1 SITE PHOTOMETRIC PLAN

FATHER & SONS

CLAREMONT BUSINESS PARK LOT 9-2
 1405 SELIX GROVE
 COLORADO SPRINGS, CO 80915
 EL PASO COUNTY, COLORADO

SP0.1

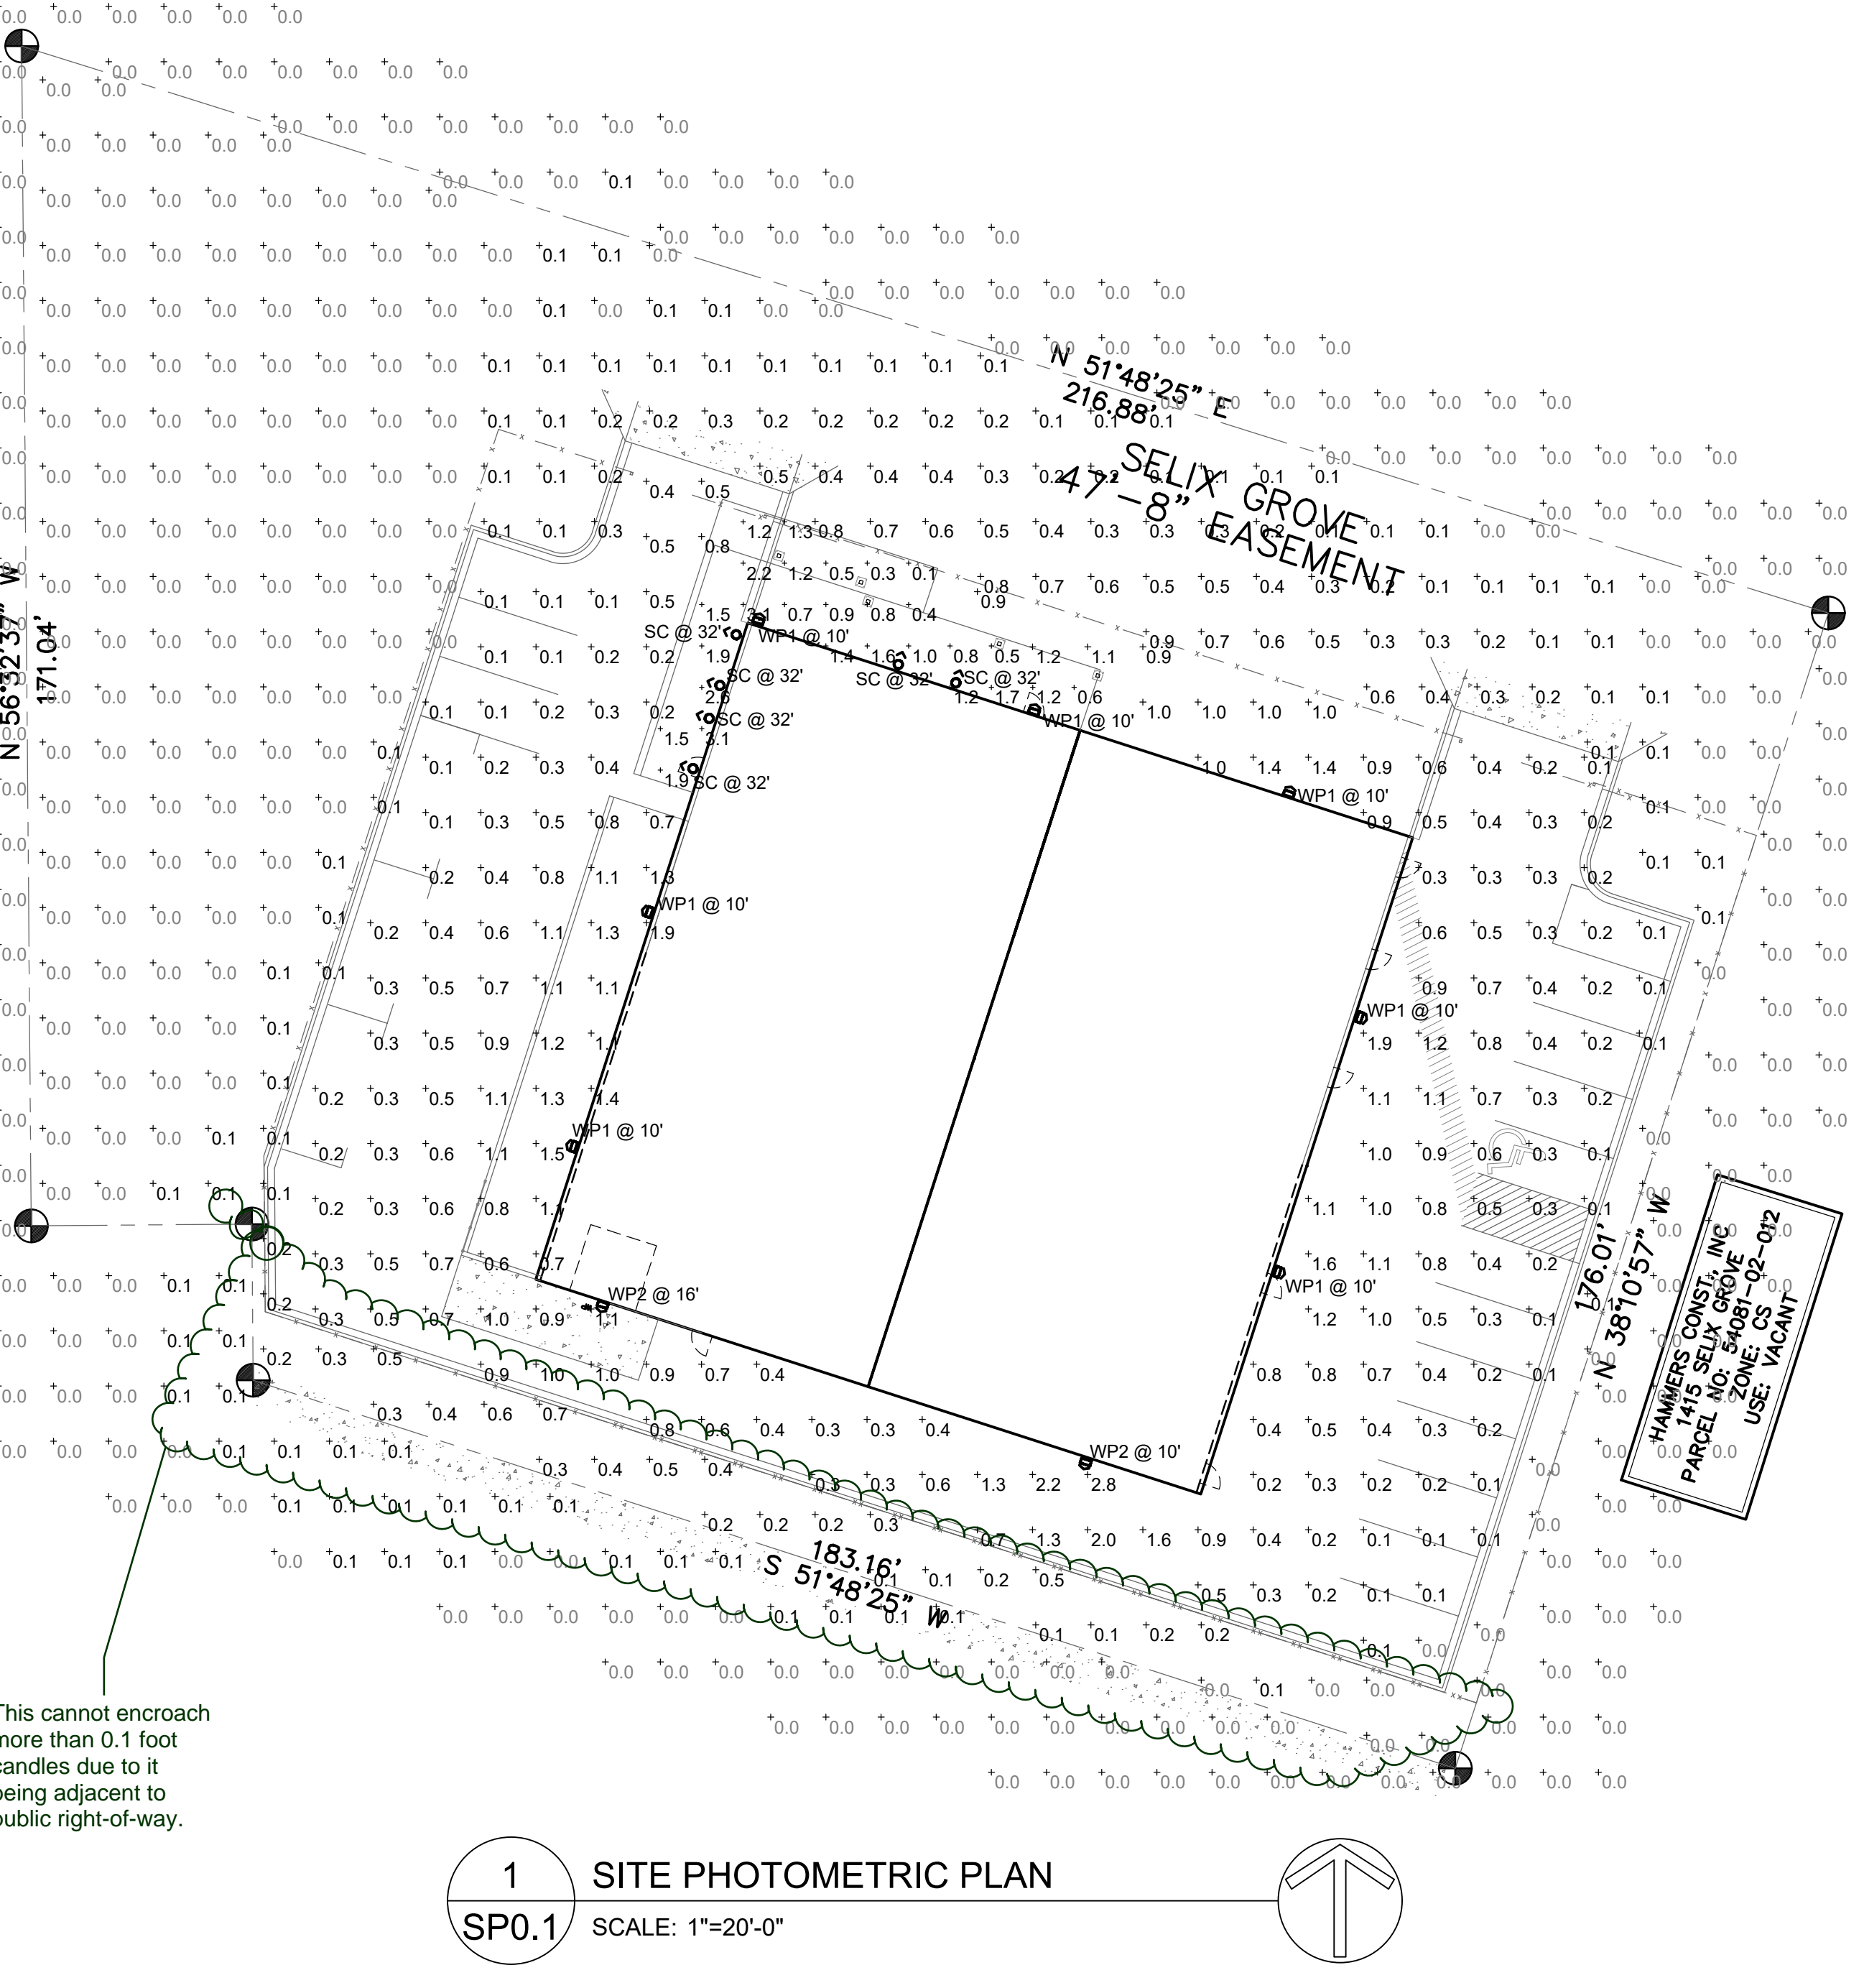
NOTES:
 This cannot encroach more than 0.1 foot candles due to it being adjacent to public right-of-way.

This cannot encroach more than 0.1 foot candles due to it being adjacent to public right-of-way.
